Implementors' Guide for ITU-T Recommendation G.168

This Implementor's Guide contains technical corrections and clarification for the implementation of ITU-T Recommendation G.168 (06/02).

Figure 13/G.168 - Test No. 2C signal and time relationships

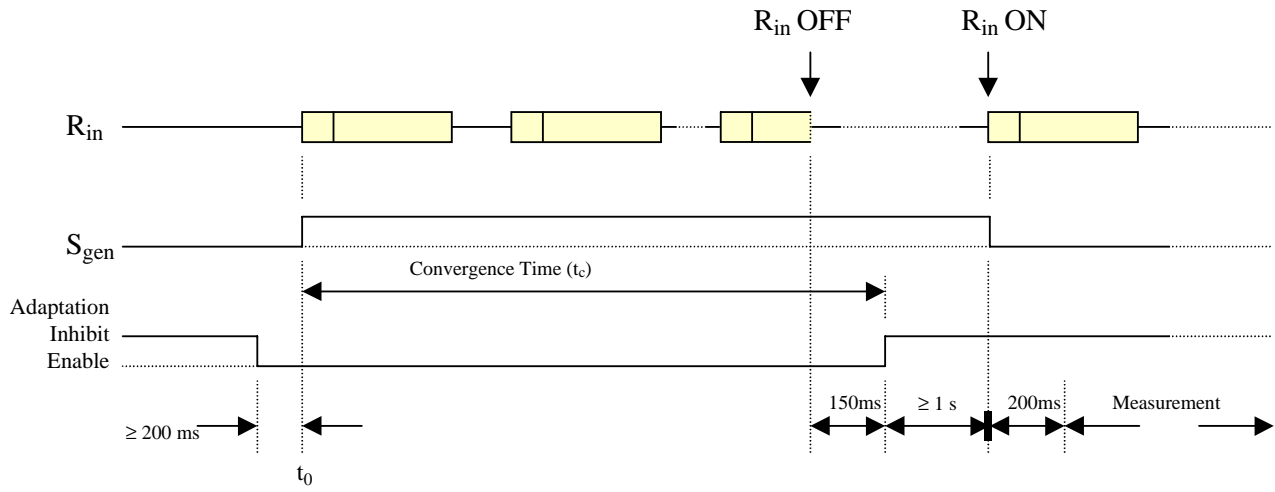
- Add t_0 to Figure 13/G.168
- The convergence time allowed in Test 2C part (c) is 10 s
- The requirements graph in Figure 16/G.168 should be truncated after $10s + t_d$ since the steady state requirement for Test 2C is given in part (b)
- Add the following note under part (c):

- A delay to the start of the measurement interval is re-introduced into the timing diagrams for Test 2C and also for Tests 3A and 3B if the 6.4.1.2.1 measurement method is used. The energy stored in the bandpass filter will propagate out in less than 13ms. The output from the exponential filter will decay by about 46dB in 187ms. Therefore, a total delay of 200ms before starting the measurement is more than adequate. This is shown in the modified Figures 13, 17 and 18.

Figure 22: Performance requirements for test 7

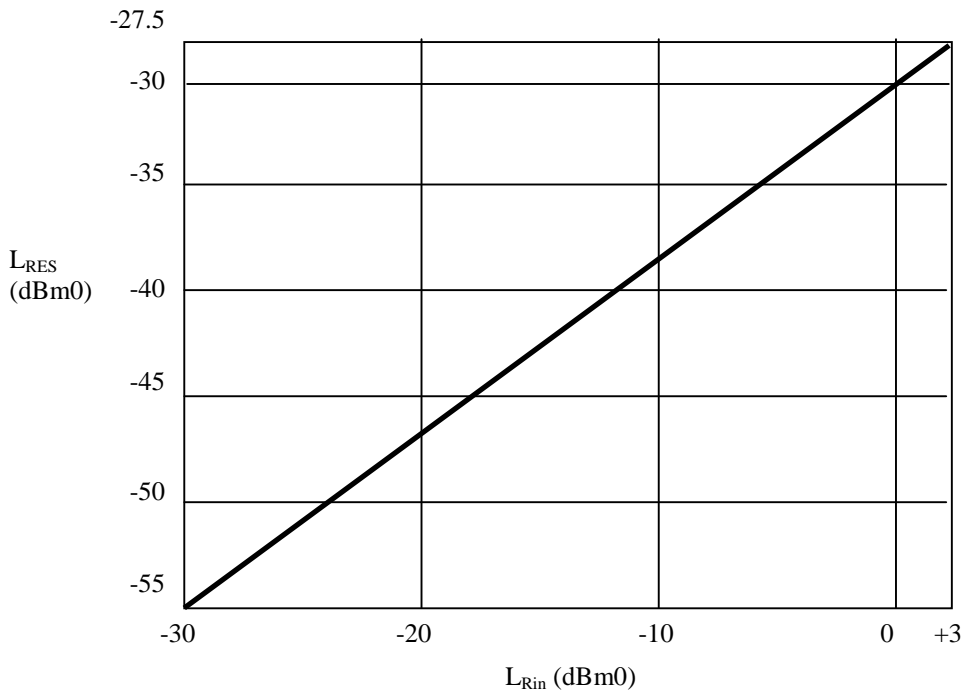
The requirements for Test No. 7 are given in Figure 22/G.168. This graph gives L_{RES} plotted against L_{Rin} . The graph is intended to be a straight line between the following two co-ordinates:

(-30, -55)

(+3, -27.5)

The graph in Figure 22 is correct at these two points, but due to unequal spacing, is incorrect everywhere else. Figure 22 should therefore be deleted and replaced with the following:

Note that the equation for the line in Figure 22 is: $L_{RES} = 0.83L_{RIN} - 30$
